Illinois Tollway Base Sheet Revisions

Section M		Base Sheet Drawings	
Drawing	Modification Summary	Effective: 2020-03-01	
Pole Assembly (ITS)-Series 1000			
M-ITS-1000	Elevation Views Pole Mounted ITS Element Assembly		
	Use 1 1/2" stainless conduits for power and fiber to ITS Enclosure instead of 2". Corrected the MVDS mounting height on elevation details Use 1 1/2" stainless conduit for ITS Disconnect switch		
M-ITS-1001	General Notes Pole Mounted ITS Assembly		
	Note added on placement of battery enclosure		
M-ITS-1002	ITS Standard Foundation		
	Note added to use 12 ft helix foundation for slopes over 1:6		
M-ITS-1003	ITS Concrete Service Pad		
	Shows option for back-to-back mounted ITS enclosures.		
M-ITS-1004	Cabinet Wiring Diagram - ITS Pole Mounted Enclosure (Solar Powered MVDS) (2 sheets)

100 FT. MONOPOLE CLOSED CIRCUIT TELEVISION (CCTV) CAMERA TOWER

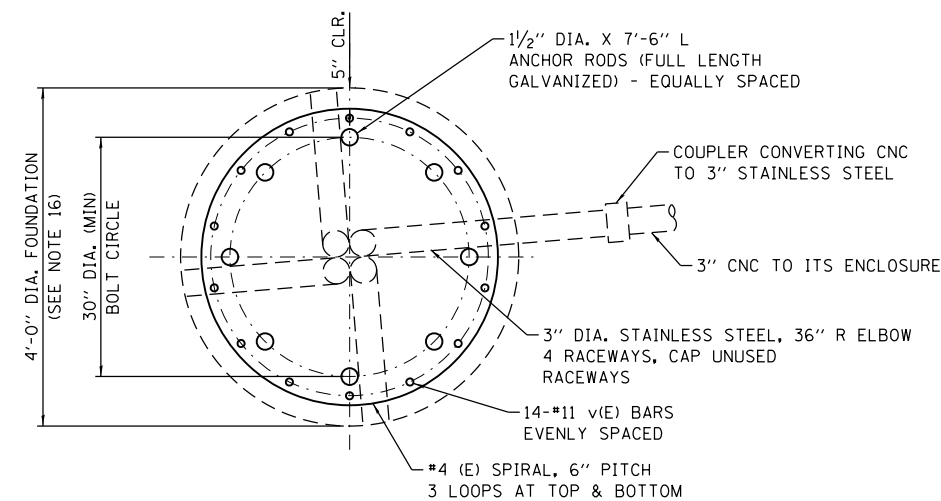
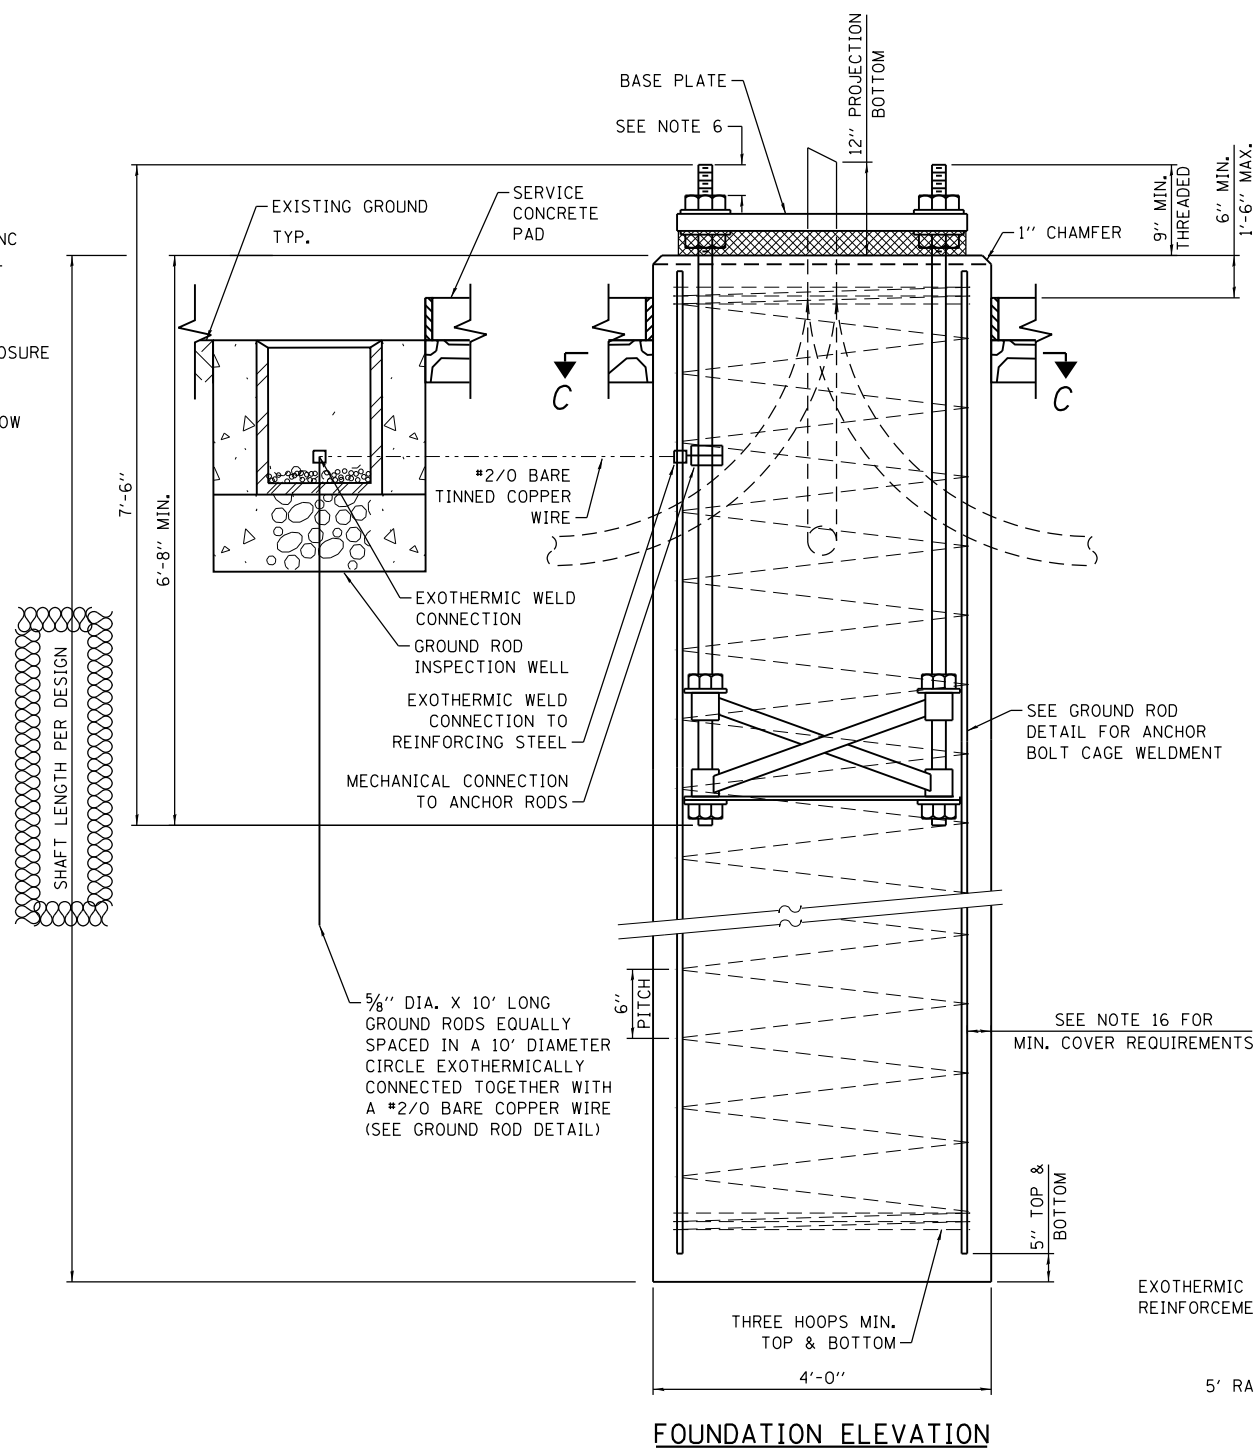
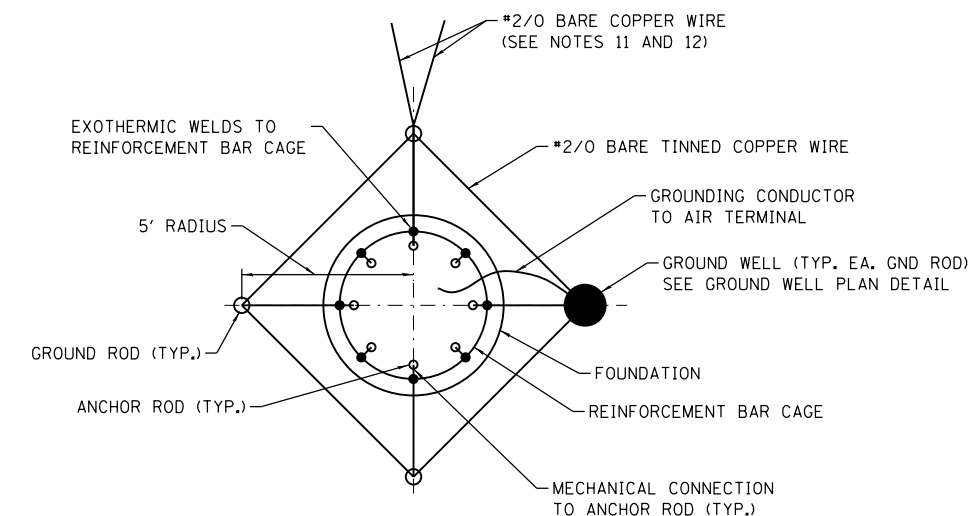
Show two permanent antennas installed on top of WIM cabinet		
M-ITS-1603	Weigh-In-Motion Detector Loop and Quartz Sensor Detail		
	Show parking area for one vehicle for annual calibration		
M-ITS-1607	Weigh-In-Motion Height Detector		
	Added detail for overheight detector		
Flashing Sign Beacon (ITS)-Series 1700			
M-ITS-1701	Cabinet Layout and Wiring ITS Pole Mounted Enclosure (1-CCTV and Flashing Sign Beacon)		
	Update enclosure layout		
IPDC Facility (ITS)-Series 1800			
M-ITS-1800	IPDC Facility		
	No change		
Conduit Details at Integral Abutment Bridge (ITS)-Series 1900			
M-ITS-1900	Conduit Details at Integral Abutment Bridge with MSE Wall (Sheet 3)		
	No change		
100 FT. Monopole (ITS)-Series 2000			
M-ITS-2000	100 FT. Monopole Closed Circuit Television (CCTV) Camera Tower		
	Pole cap to use hex head screws		
	Show revised grounding around service pad
